Product Change Notification / MAAN-24NWLH863

CCB 6432 Final Notice: Qualification of GTBF as an additional assembly site for selected DNxxxxN8, TNxxxxN8, TPxxxxN8, VNxxxxN8 and VPxxxxN8 device families available in 3L SOT-89 package.

CCB 6432
Pre and Post Change Summary
PCN #: MAAN-24NWLH863

Lead Frame Comparison

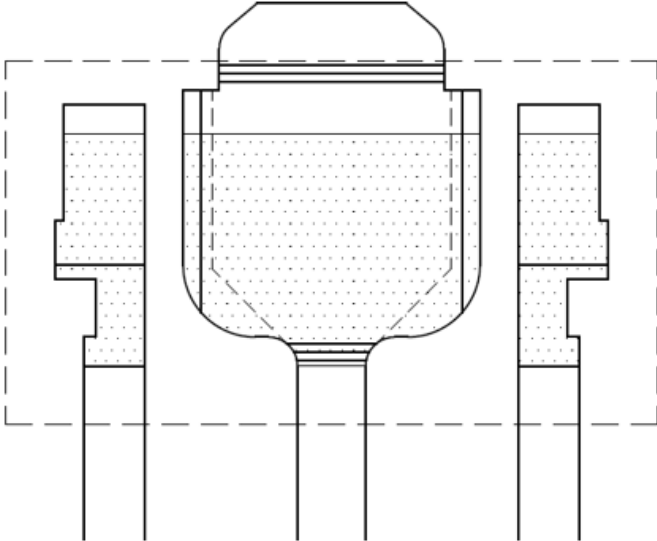
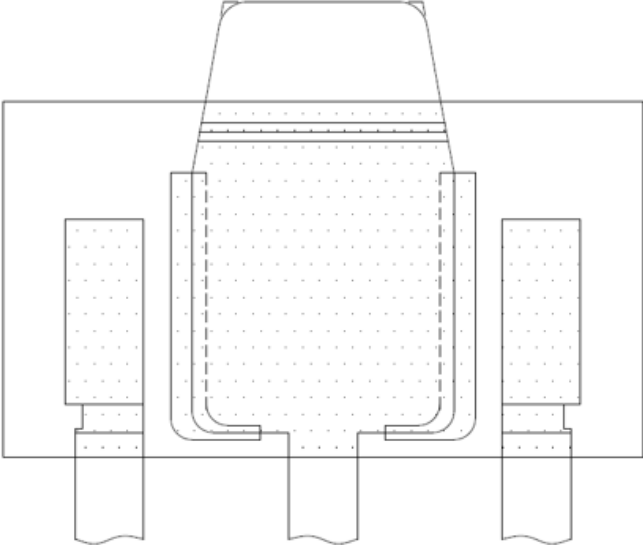
LPI	GTBF				
 <table border="1" data-bbox="257 1109 1090 1186"><tr><td>Paddle Size</td><td>79x63mils</td></tr></table>	Paddle Size	79x63mils	 <table border="1" data-bbox="1454 1109 2295 1186"><tr><td>Paddle Size</td><td>71x79mils</td></tr></table>	Paddle Size	71x79mils
Paddle Size	79x63mils				
Paddle Size	71x79mils
